NEW YORK STATE DEPT OF ENVIRONMENTAL CONSERVATION ALBANY F/6 13/13  
NATIONAL DAM SAFETY PROGRAM. PALMER FALLS DAM, UPPER HUDSON RIV--ETC(U)  
AUG 80 J B STETSON DACW51-79-C-0001  
NY-145 NL

REPORT DOCUMENTATION PAGE		READ INSTRUCTIONS BEFORE COMPLETING FORM
1. REPORT NUMBER	2. GOVT ACCESSION NO. AD-A093025	3. RECIPIENT'S CATALOG NUMBER
4. TITLE (and Subtitle) Phase I Inspection Report Palmer Falls Dam Upper Hudson River Basin, Saratoga & Warren Counties, NY Inventory No. 145		5. TYPE OF REPORT & PERIOD COVERED Phase I Inspection Report National Dam Safety Program

PHASE I REPORT  
NATIONAL DAM SAFETY PROGRAM

Palmer Falls Dam - July 10, 1913 - Pier #7, showing slope of rock ledge

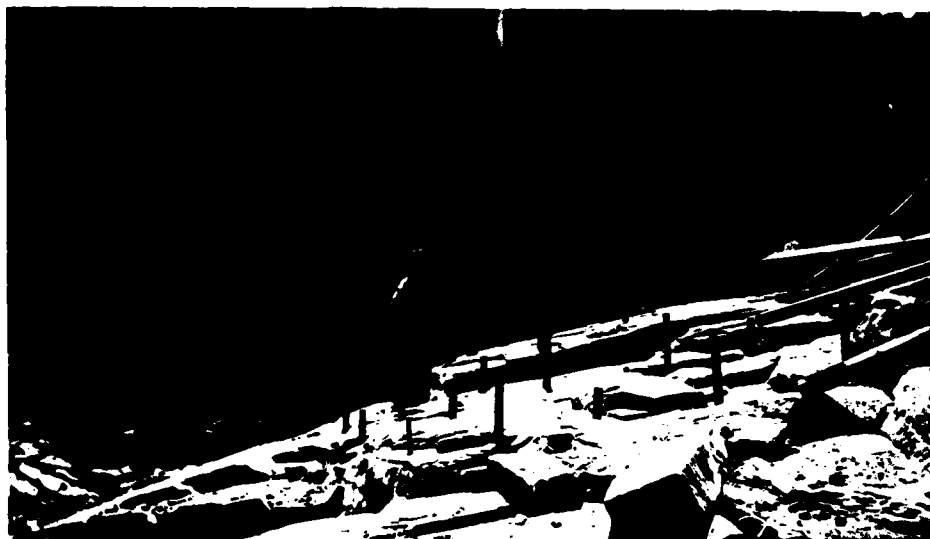
As to stability against sliding, however, the dam seems especially weak, the weakest point being pier #7, at the angle near the center of the dam. The rock surface at this point is smooth and waterworn, and has an average slope, downstream, of about 18 degrees. The forces acting on this pier have been calculated and the coefficient of friction between the masonry and rock surfaces is found to be 0.57. (See attached sheet, Acc. C-355). This is much too high for safety. The only precaution taken against sliding at this point is the placing of about 30 or 40 two inch iron rods set vertical and extending about five feet into the rock and from two to four feet into the masonry. These rods are probably of little value for this purpose.

STATE OF NEW YORK  
 CONSERVATION COMMISSION  
 DIVISION OF INLAND WATERS  
 PALMER FALLS DAM  
 SKETCH SHOWING EFFECT OF  
 WATER PRESSURE IN JOINT UNDER DAM

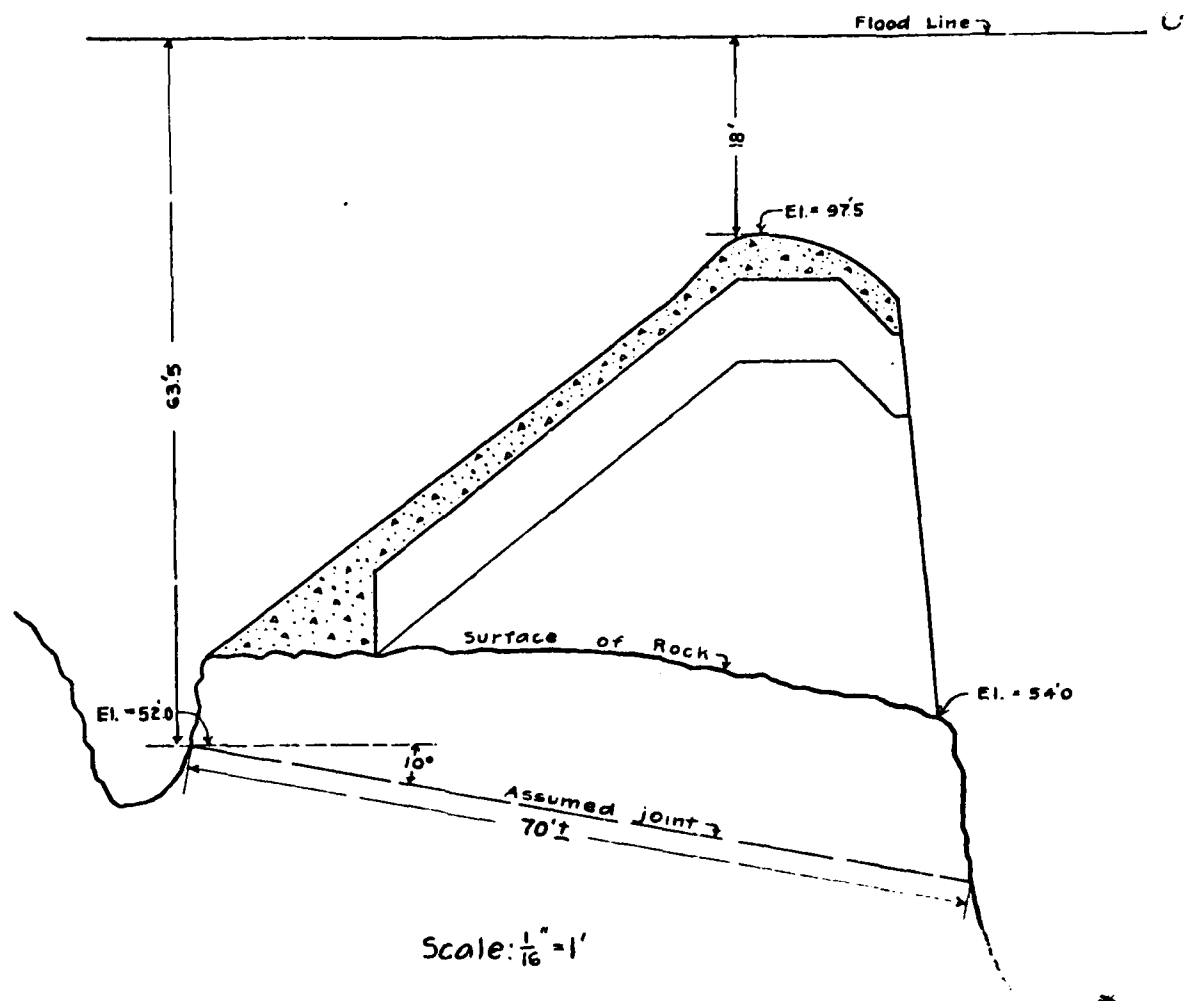
Another element of danger is the possibility of the occurrence of a crack along the bedding plane of the rock at some distance below the base of the dam and extending from the trench back of the dam entirely through to the face of the falls. At the western end of the dam this distance would not be over 70 or 75 feet. Assuming

water pressure in such a joint equal to full static head at the back, decreasing uniformly to zero at the face, and acting over two-thirds the area, the coefficient of friction along this joint is found to be 0.69, as shown on attached sheet, Acc. No. C-356.

Total vertical load on assumed joint	= 4 378 000*
Upward pressure of water (assuming full static pressure at heel, decreasing uniformly to zero at toe, effective over two-thirds area of base)	= 1 760 000*
Net vertical load	= 4 830 000*
Horizontal component of water pressure	= 2 200 000*
Total pressure parallel to joint	= 3 005 000*
" " perpendicular to joint	= 4 378 000*
Coefficient of friction	= 0.69
